Design Issue Software Improvement

Published date	2003/12/11	Quality record No.	EA734EF021S00
----------------	------------	--------------------	---------------

Machine model	734	Machine model name	MAZATROL FUSION 640T/MT/TE		Area Spec	ALL
Unit group		Unit name			NC Unit	M640MT
Summary	MAZATROL FUSION 640T/MT/TE 出図完了報告書 < D 4 版 > MAZATROL FUSION 640T/MT/TE Drawing release completion report <version D4>					
Computer		Operating System		Software Name	M640T/MT/TE	D4
Machine S/N		Customer name			Adaptation Time

1. [Outline]
This is a report that drawings of MAZATROL FUSION 640T/MT/TE Software version D4 are released.
For the details, refer to the attached "Version D4 drawing release".

Re-threading

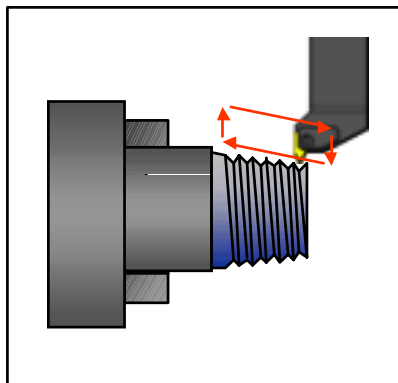
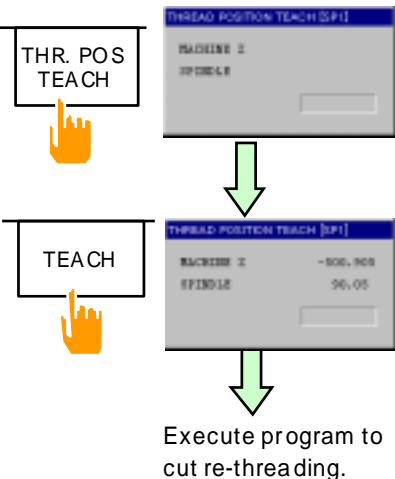
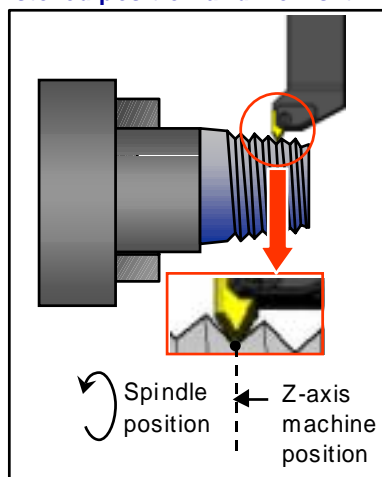
After the workpiece has been removed from the chuck and remounted for re-threading, it is possible to store the re-threading position and then engaging the tool nose of the threading tool with the groove of the thread, and the threading tool runs through the stored position and works it. Up to now, when a workpiece that has been removed from the chuck is remounted, the starting position of re-threading is changed and this requires test cutting. The use of this option, however, makes machining tests unnecessary, allowing easy re-threading.

The worker adjusted the phase gap of spindle by test cutting repeatedly.

After engaging the tool nose of the threading tool with the groove of the thread, and store the re-threading position (Spindle position and Z-axis machine position) When execute a program, the threading tool runs through the stored position and works it.

TEACH function in the TOOL OFFSET display

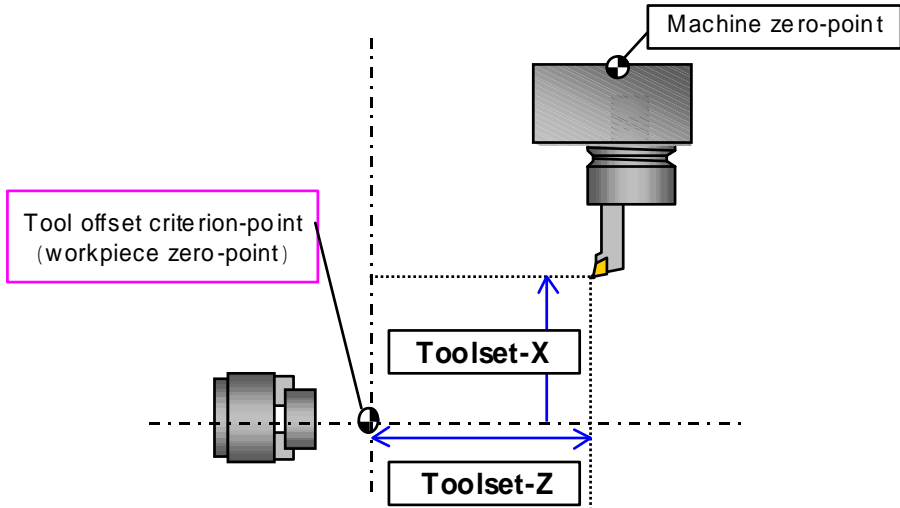
The TEACH function was added in the TOOL OFFSET display. In this function, it is possible to set up distance from the tool nose to the tool offset criterion point as toolset value automatically.

When the parameter P8 bit3 is "1", this function becomes valid.

Additional save of programs in Hard disk/Floppy disk data input/output

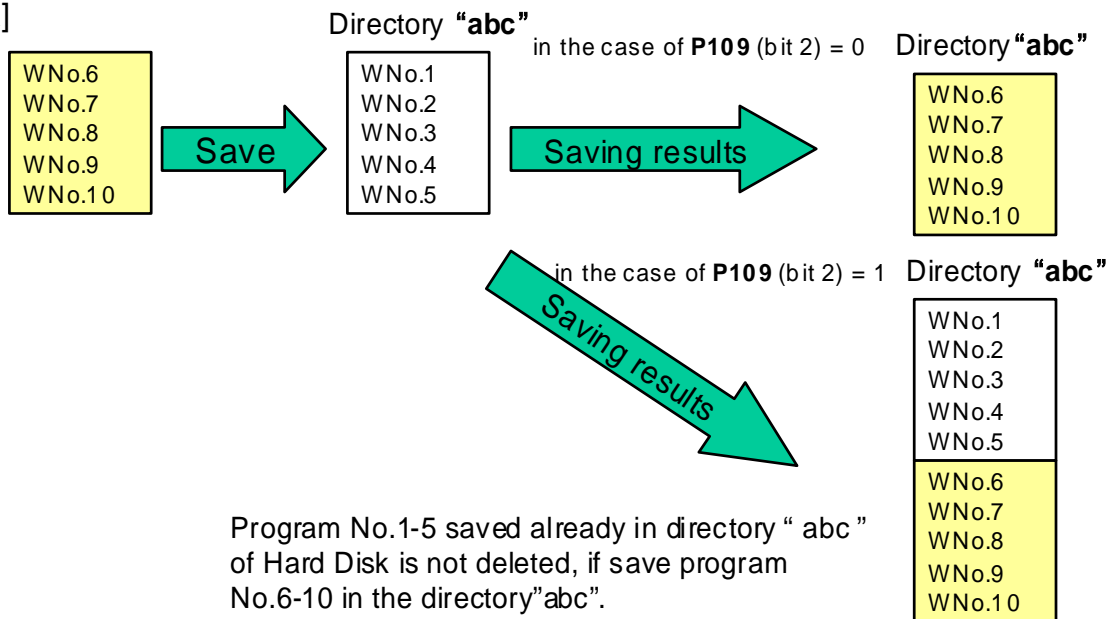
It is possible to additional save of programs in Hard disk/Floppy disk data input/output by setting of parameter.

Note) If the same program No. and data except program already exists, this data (Tool data and tool file etc.) will be overwritten.
